Date: April 26, 2023
To: Dago Garcia, P.E., City Engineer
Cc: Roy Reyes, Project Engineer
Chris Kerr, AICP, Community Development Director
John Raugust, PE, AKS Engineering & Forestry
From: Colin Cortes, AICP, CNU-A, Senior Planner *CC*
Subject: **Planning Division review comments on 3rd / 2nd revised submittal April 12 of civil engineering plans for Macadam at Tukwila PUD (f.k.a. Marion Pointe)**

On behalf of the Planning Division, I reviewed a revised copy of the civil engineering plan set submitted April 12 and compared it with the review memo of March 30 and for conformance with the Annexation ANX 22-02 land use final decision conditions of approval (AKS Job Number 7564).

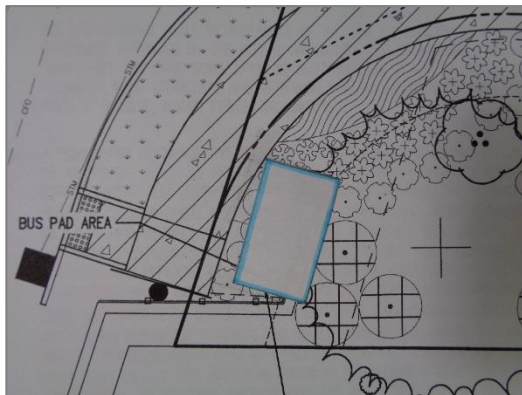
O5: Part D: Staff observes simply that if the proposed retaining wall that straddles N. Boones Ferry Road ROW and Tract H shifts during civil engineering plans (as seen through Sheets C103 and L105), to maintain within the bus shelter public easement that Table 203D requires for Tract D enough room and reasonable grade to fit a bus shelter pad, specifically a rectangle 12 x 7 ft per [INT 22-0609](#).

The Sheet L105 delineated and noted area isn't minimum 12 ft wide parallel to the road and 7 ft deep between sidewalk and retaining wall. Revise to expand and re-delineate the rectangular minimum area.

✗ Sheet L105 remains unchanged for this item.

The photo below of marked Sheet L105 illustrates the scaled blue-outlined rectangle aligned with sidewalk without encroaching on the sidewalk curve to the northeast. It illustrates that the NE segment of the proposed retaining wall can't fit a pad 7 ft deep from sidewalk and 12 ft wide along sidewalk and indicates how to shift the wall's segment east.

AKS DRAWING FILE: 7564 L100 LANDSCAPE PLAN LAYOUT: L104

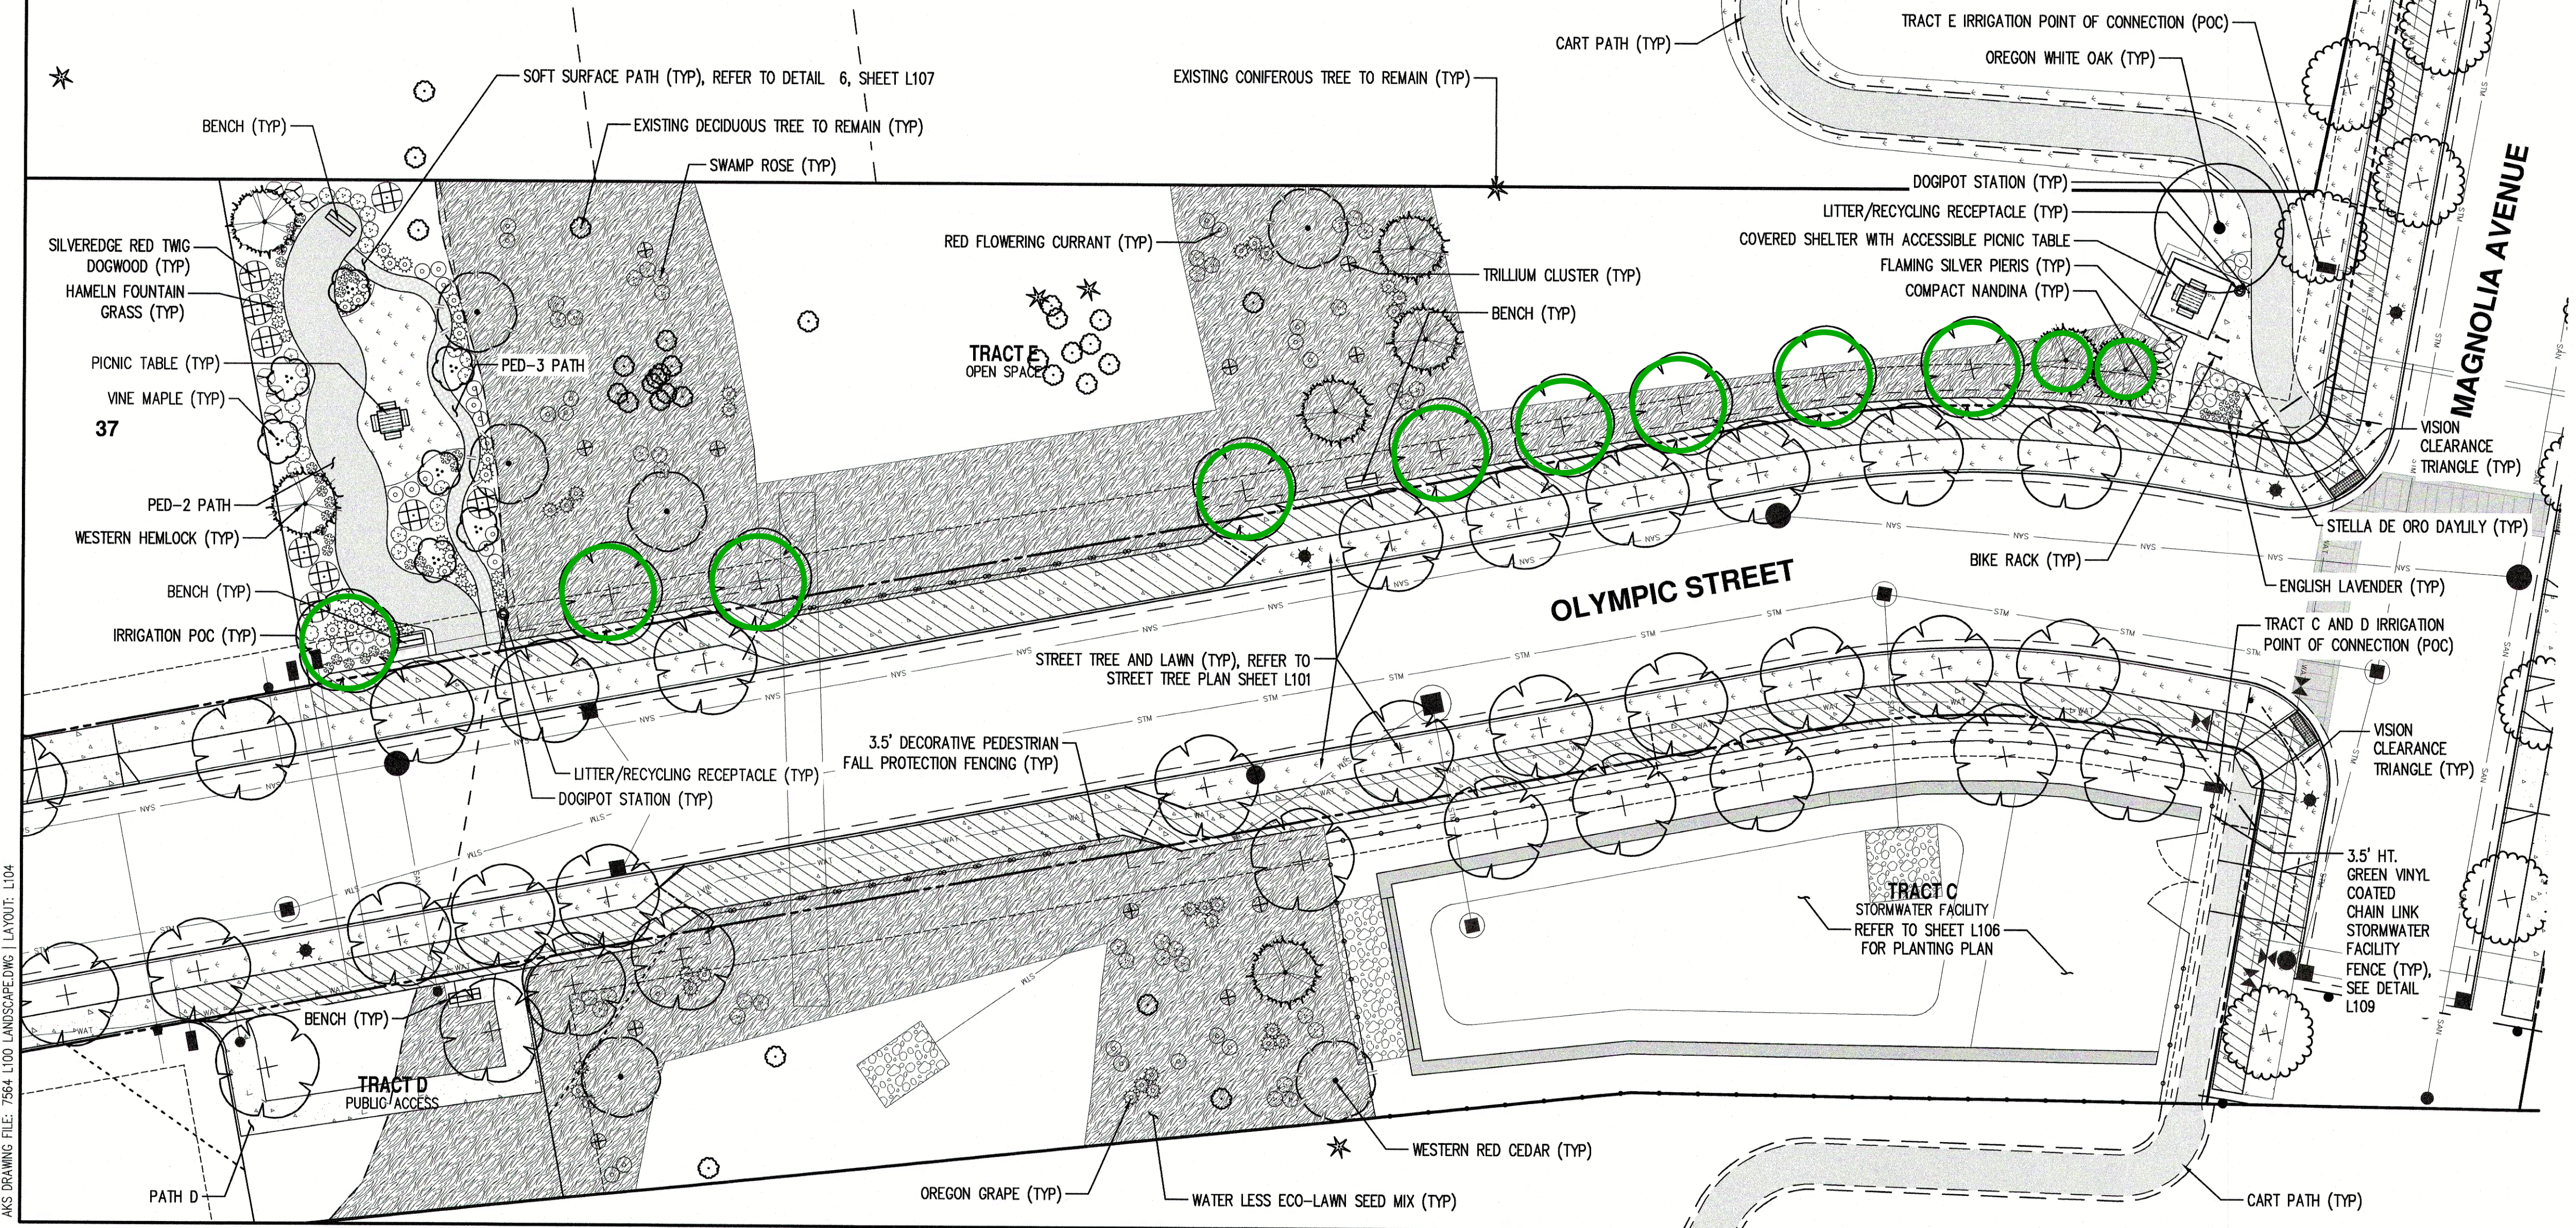
O3c: Tract E: Relocate or add 2 trees to meet min 14 within 5-14 ft of ROW. Revise ... L104.

✘ Sheet L104 remains unchanged for this item.

Attached is a marked copy of Sheet L104 with green circles indicating what trees that staff counted as the 11 that both the March revision and the present April proposal illustrate within a band 5-14 from ROW.

Within this band, either relocate 2 trees from outside the band or add 2 trees to the band to meet the requirement.
